Service Info

Coolant pump 538 0021 10

Modified housing

Part no.: 538 0021 10

Figure 2: New design

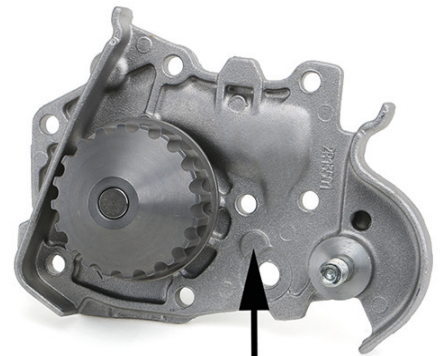
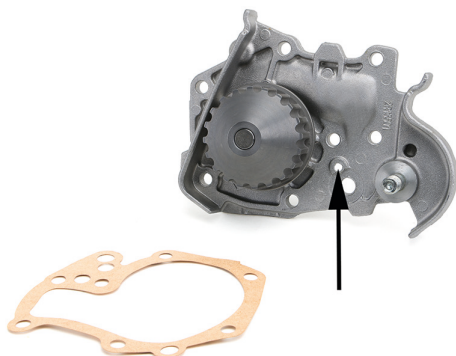
Coolant pump 538 0021 10 has been modified. In the new design, one of the holes in the housing has been eliminated (Fig. 2).

During the transition phase, stocks may become mixed with both new and old design parts.

Both versions meet the technical specifications and can be used without restriction.
